Linwood Recreation Center Site Improvements

ONLINE SURVEY RESULTS

August 16th - September 13th

Overall Site Plan

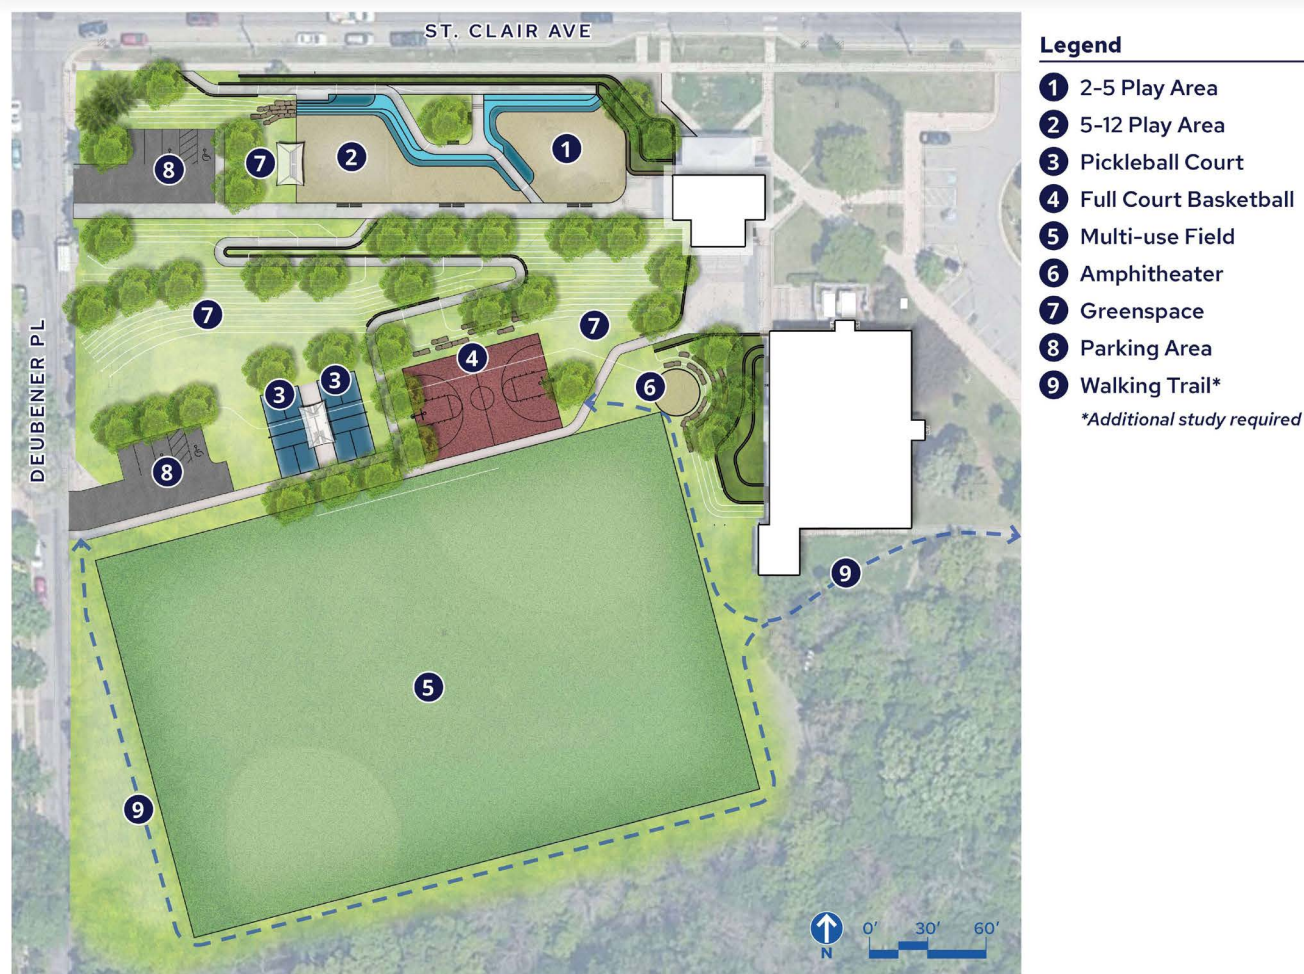
- "Second parking area on the lower field seems excessive."
- "I'd add in a splash pad. Highland/summit hill/mac groveland is missing this critical feature."

- "There really should be a fenced area for dogs. If there isn't a designated spot that field is going to be used as an unofficial off leash area which will in turn limit usage for everyone else. I've seen parks that have put in outdoor hockey rinks that area used as dog runs in the summer."

- "It looks great overall -- I like the thoughtful inclusions of different-level play areas. Three thoughts: 1. As a recent pickleball convert who is very aware of how popular the sport is (and how quickly the existing courts fill up), I am wondering if two courts are enough. And 2. The proposed parking spaces (I realize they are in addition to a bigger lot to the east) seem woefully inadequate UNLESS they can be offered as an alternative to public transportation. Is there a way to petition the city to reinstate the St. Clair bus service -- the late, great No. 70 -- that was discontinued several years ago? 3. I hope that the Multi-Use Field will include ice-skating in the winter, and that some part of the existing rec building can serve as a warming house. :-)"

- "1) Love the walking trail area 2) Curious if the multi-use field will be natural grass or turf (I'd vote turf)."
- "I like it! Using the hills and incorporating natural elements is very good!"

- "Connectivity from the play area to the lower fields is currently via a staircase near the community center - this staircase also helps retain the hillside. Although it is showing signs of its age - I would recommend refurbishment of this staircase to provide a more direct outside connection from the play area down to the lower field. The accessible path is great - but the quicker more direct access the stair currently provides would be nice to salvage. #9 - The trail connection from the lower western side to the higher eastern portion of the park would be tremendous. This wouldn't need to be accessible (other routes provide accessibility). #6 If value engineering is necessary to align the budget with the project scope - I would give up the amphitheater."
